Site Accessibility Evaluation

Fire Station 21

Accessibility Evaluation

SUBJECT: Fire Station 21 Self-Evaluation

Finding: 1

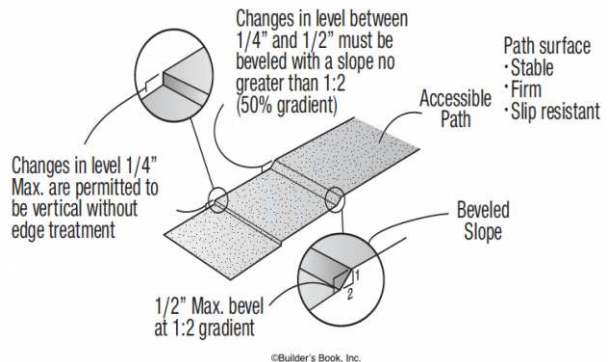
The accessible route contains loose gravel and/or surfaces that do not provide for a stable, firm slip resistant surface.

2010 ADAS Section: 302.1

The community garden is accessed via a loose chip rock path.

Pave a path between the driveway and the community garden. The new pavement would be about 25' in length. The existing gravel path is about 4' wide.

Finding: 2

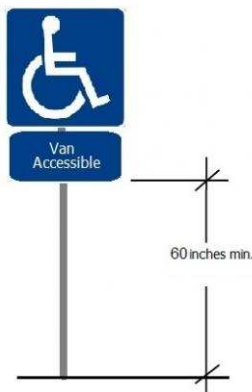
The required parking signage is missing.

2010 ADAS Section: 502.6

The accessible parking space does not have post-mounted signage.

Install post-mounted signage at the accessible parking space, including a van accessible sign.

Finding: 3

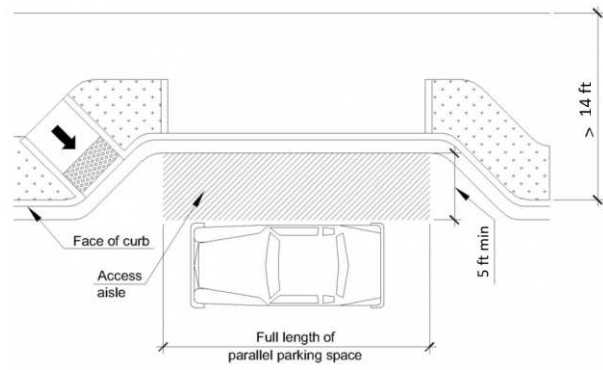
The access aisle is missing for the accessible parking space. The parallel AC space is 22' long with asphalt to hashing and 6'11" wide. If you include the gutter pan, the width of the AC parking increases to 8'11" wide. We need 13' of space.

2011 PROWAG Section: R309.2.1

There are not access aisles at the accessible parking spaces.

Add access aisles.

Finding: 4

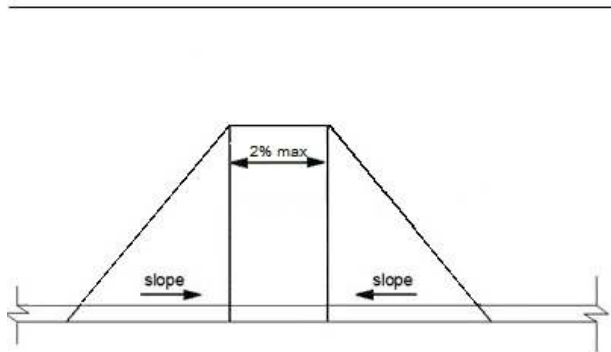
The curb ramp on the accessible route contains cross slopes greater than 2%.

2010 ADAS Section: 405.3

The curb ramp has cross slope of 4.5%.

Remove and replace the curb ramp.

Finding: 6

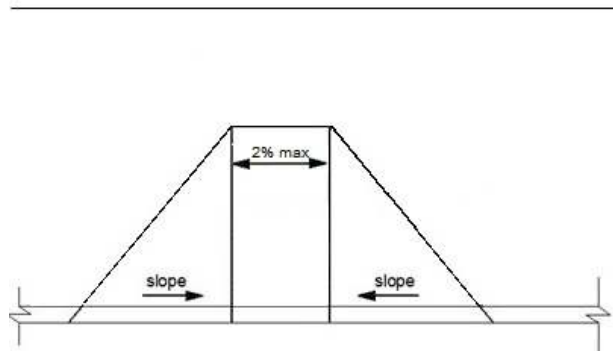
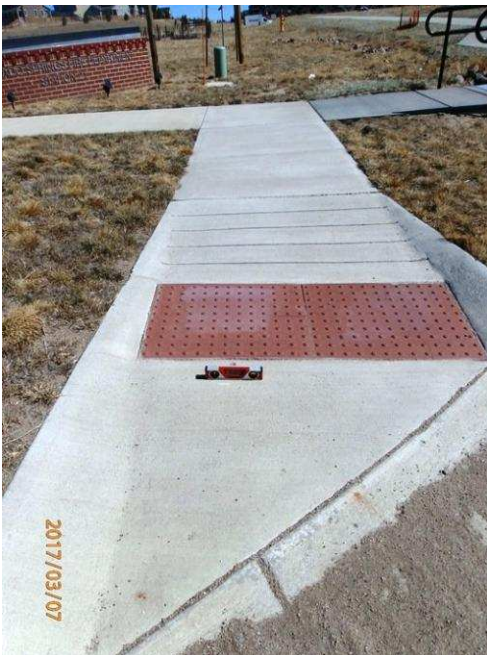
The curb ramp on the accessible route contains cross slopes greater than 2%.

2010 ADAS Section: 405.3

The curb ramp has cross slope of 4%.

Remove and replace curb ramp. It might be this ramp must be sloped due to adjoining street. However, it appears this is not the case.

Finding: 7

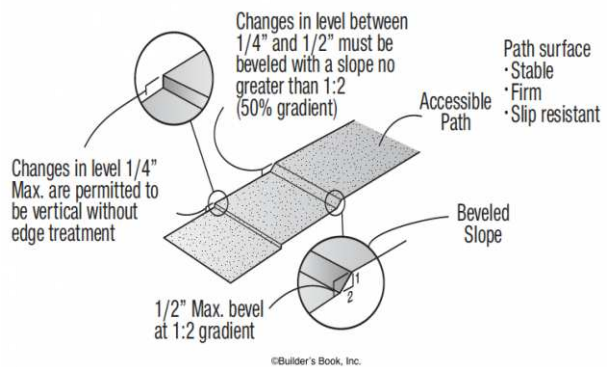
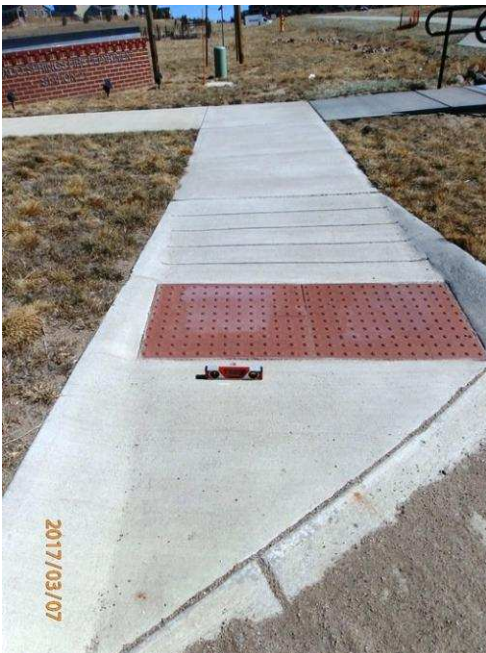
The surface of the curb ramp is not firm, stable and/or slip resistant..

2010 ADAS Section: 302.1

The gutter of the curb ramp is full of debris and dirt.

Keep the curb ramp gutter clear of debris and dirt.

Finding: 9

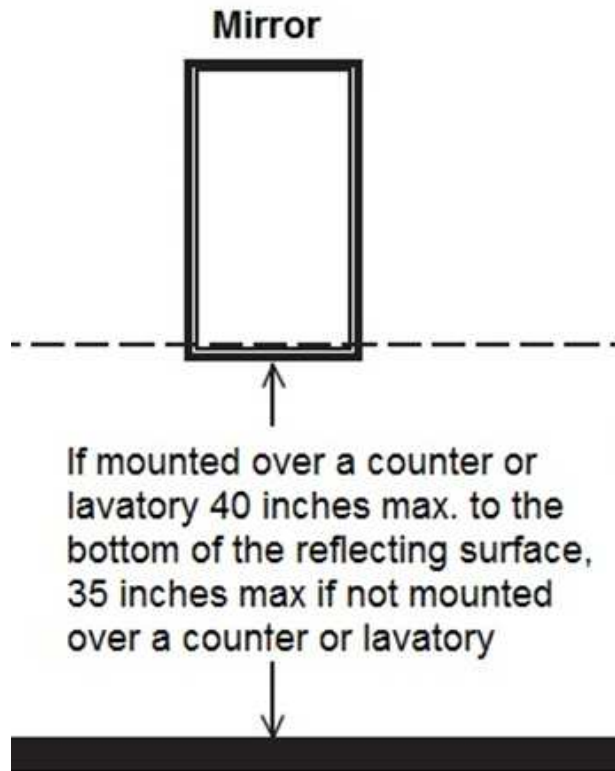
The mirror is mounted too high.

2010 ADAS Section: 603.3

The mirror is mounted at 41" to the reflective surface.

Due to how the mirror is mounted, it may be more economical to add a full length mirror on an adjacent wall rather than lowering the mirror above the lavatory. The bottom edge of the reflective surface of the full length mirror should be at 35" maximum from the floor.

Finding: 10

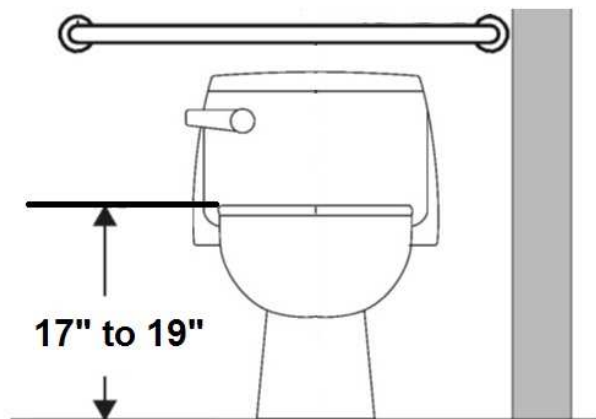
The toilet seat is not located within the range allowed off the floor.

2010 ADAS Section: 604.4

The toilet seat is 16-1/2" high.

The toilet seat needs to be 17" to 19" to the top of the seat. Explore a high-profile toilet seat (maximum 2" height). Otherwise, the toilet base will need to be replaced which is likely the needed course as the flush is on the wrong side and tank will need replaced.
